ORIGINATION FORM

Proposed Revisions to a Standard Plans Index

Index Number: 700-110

Index Title: Mounting Exit Number Panels to Signs

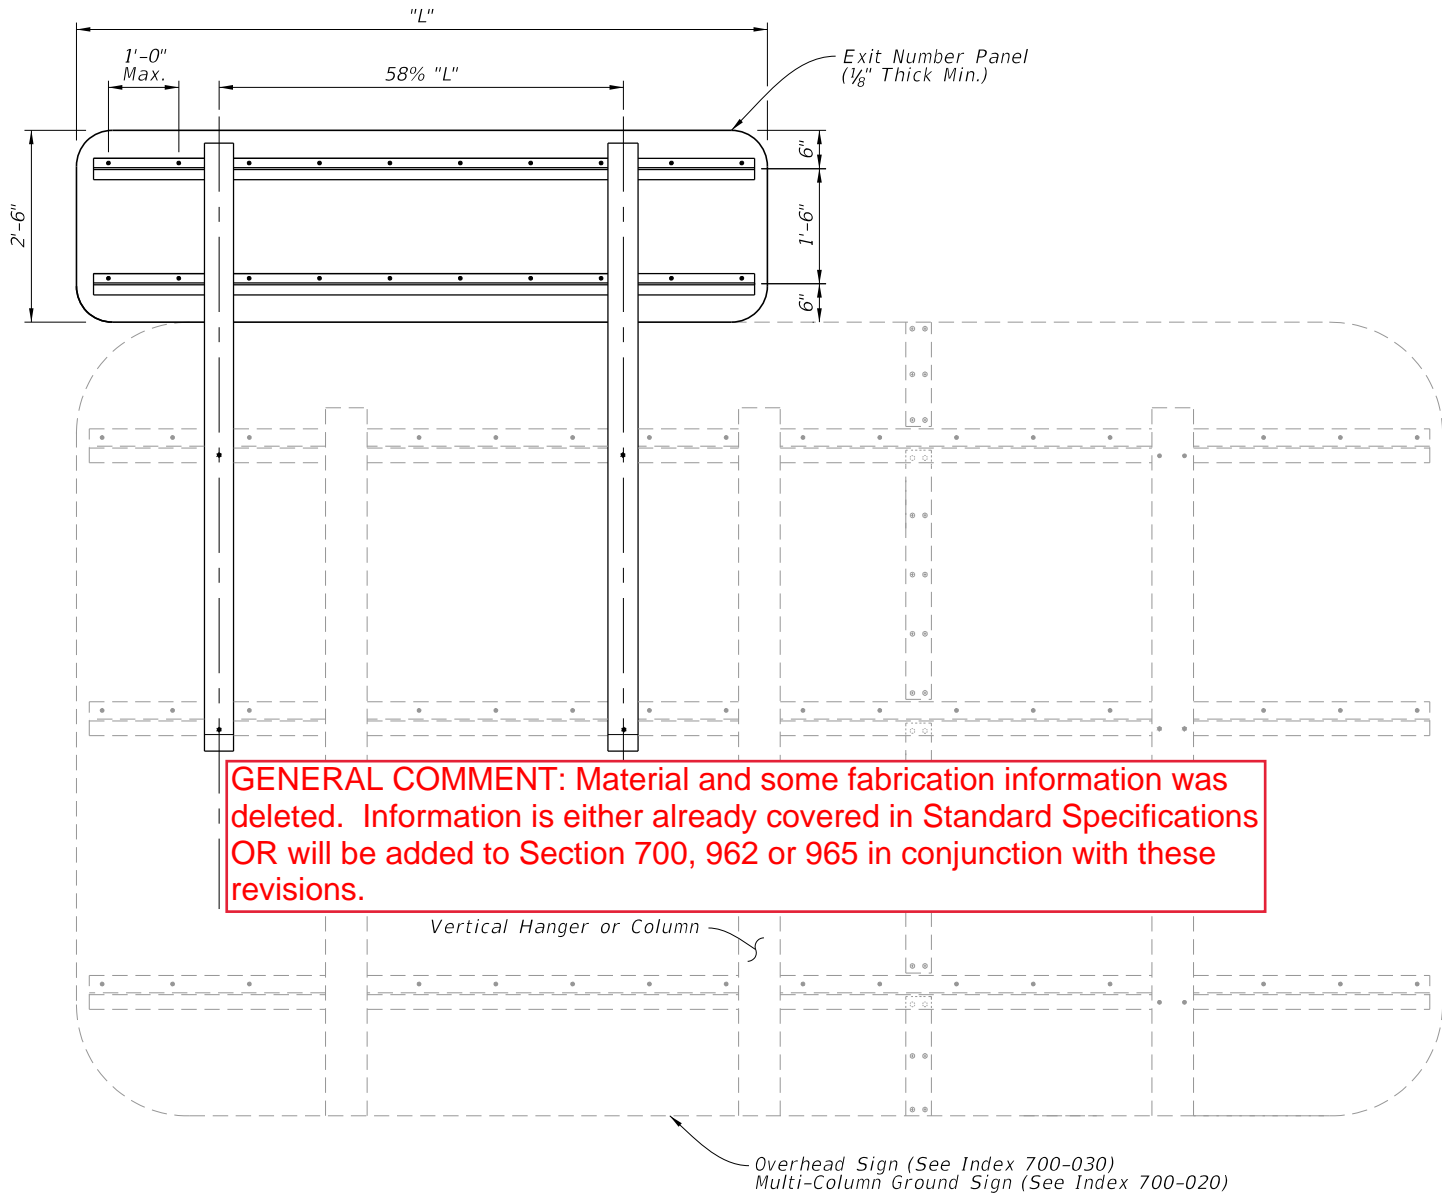
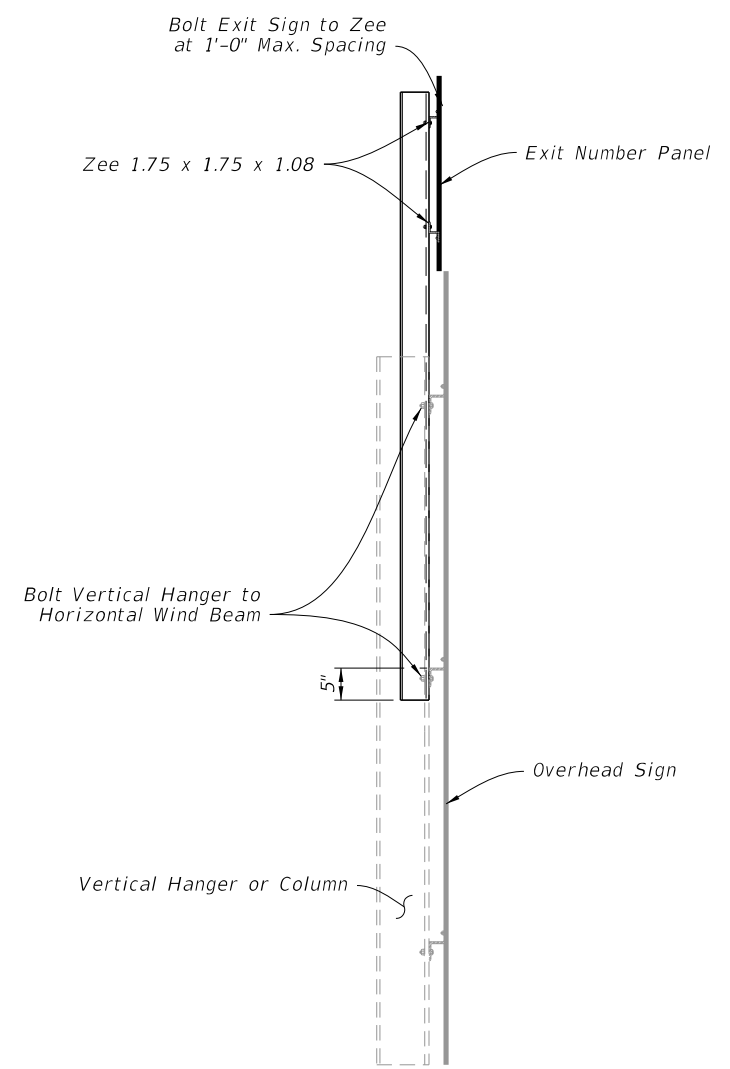
ADDED NEW NOTE 1: Meet the requirements of Specification 700.

1. ~~NOTES:~~ UPDATED: GENERAL NOTES:

2. ~~1. Work with Indexes 700-020 and 700-030.~~
- ~~2. Materials (Aluminum):~~
- ~~A. Sheets and Plates: ASTM B209 Alloy 6061-T6~~
 - ~~B. Standard Structural Shapes: ASTM B221 Alloy 6061-T6~~
 - ~~C. Extruded Shapes: ASTM B221 Alloy 6061-T6~~
 - ~~D. For Bolts, Nuts, and Washers requirements see Index 700-020 or 700-030.~~
3. Fabrication:
- ~~A. See sign layout sheet for dimension "L" and sign face details in the Plans.~~
 - ~~B. Round all sign corners.~~
4. For right exits, install the Exit Numbering Panel to the top right side of the Highway Sign.
5. For left exits, install the Exit Numbering Panel to the top left side of the Highway Sign.

DELETED

DELETED:

GENERAL COMMENT: Material and some fabrication information was deleted. Information is either already covered in Standard Specifications OR will be added to Section 700, 962 or 965 in conjunction with these revisions.
